RE: 955 Sansome Street (2021-0009035PPA)

As you may recall, the Telegraph Hill Dwellers' Planning and Zoning Committee invited you to participate in our discussion of your proposed project at 955 Sansome Street. Because you declined our invitation, we have reviewed the plans and massing study that you submitted to the Planning Department with your Preliminary Project Assessment (PPA) Application.

Figure 1 – 955 Sansome is located in the Northeast Waterfront Historic District.

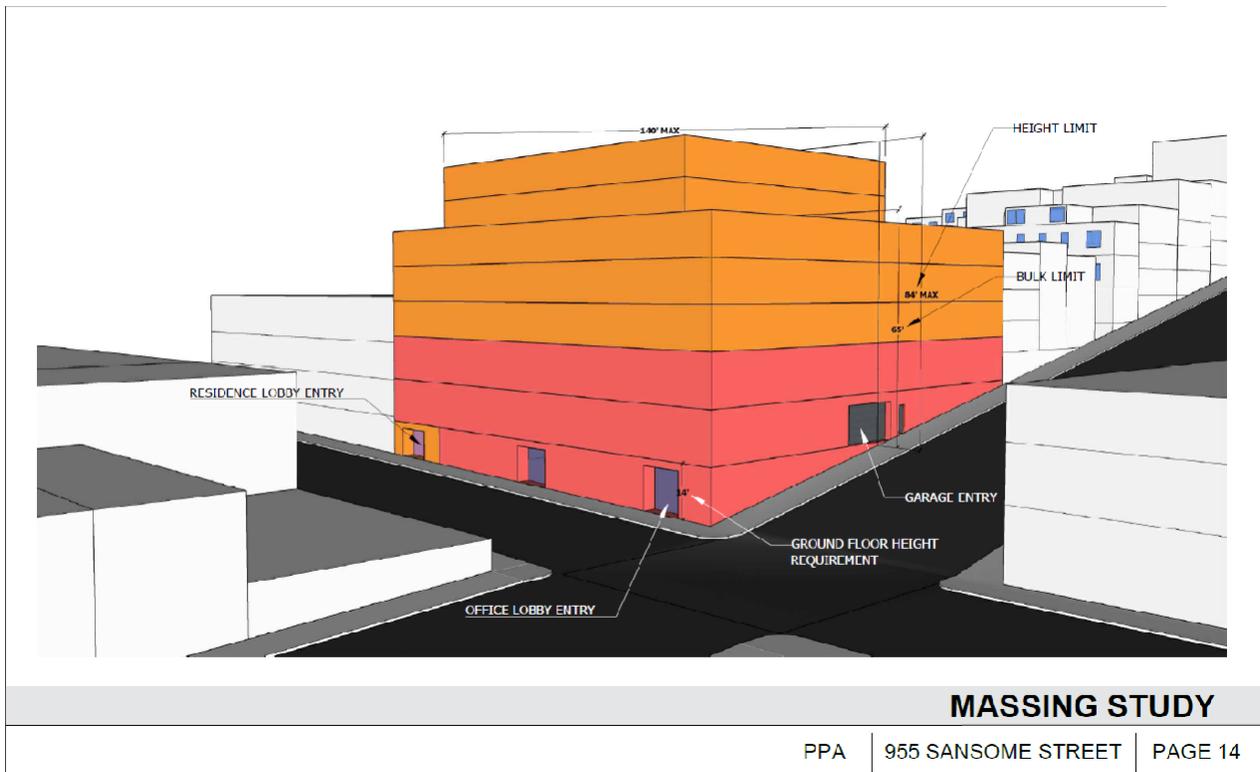
We are concerned that the building as described in your plans and massing study is not compatible with the historic district in which it is located. The site of the proposed building is in the Northeast Waterfront Historic District (see Figure 1). As such, a Certificate of Appropriateness (COA) is required under Planning Code Sec. 1006(1), without which, under the conformity and permit provisions of Sec. 1005, no City permits can be issued. To approve a COA, the Historic Preservation Commission (HPC) must make certain findings under Sec. 1006.6, including the following:

*“(d) For applications pertaining to property in historic districts, other than on a designated landmark site, **any new construction, addition or exterior change shall be compatible with the character of the historic district...** for any exterior change where the subject property is not already compatible with the character of the historic district, **reasonable efforts shall be made to produce compatibility, and in no event shall there be a greater deviation from compatibility...**” [bolding added]*

RECOMMENDATION: We urge you to materially reduce the size of your proposed building and design it to be compatible with the historic district.

Figure 2 – 955 Sansome would be significantly taller and more massive than adjoining buildings.

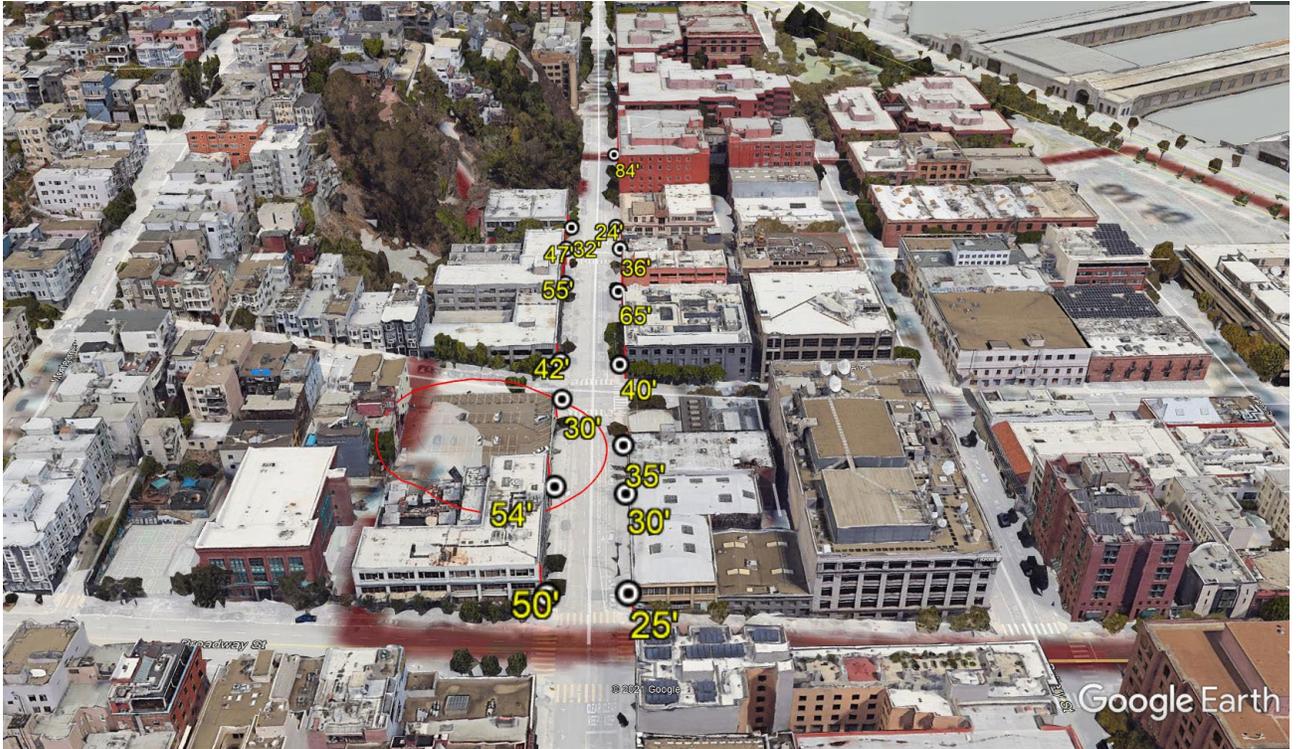
We recognize that, at least at the time of our P&Z Committee meeting, you had not yet retained an architect. Nonetheless, we strongly believe from your PPA plans and massing study (see the rendering in Figure 2) that the HPC will be unable to make the above required COA finding. As proposed, your building would be substantially higher and more massive than adjoining structures, it would not conform to the prevailing character of the Northeast Waterfront Historic District, and it would constitute a materially greater deviation from compatibility than the existing structure.
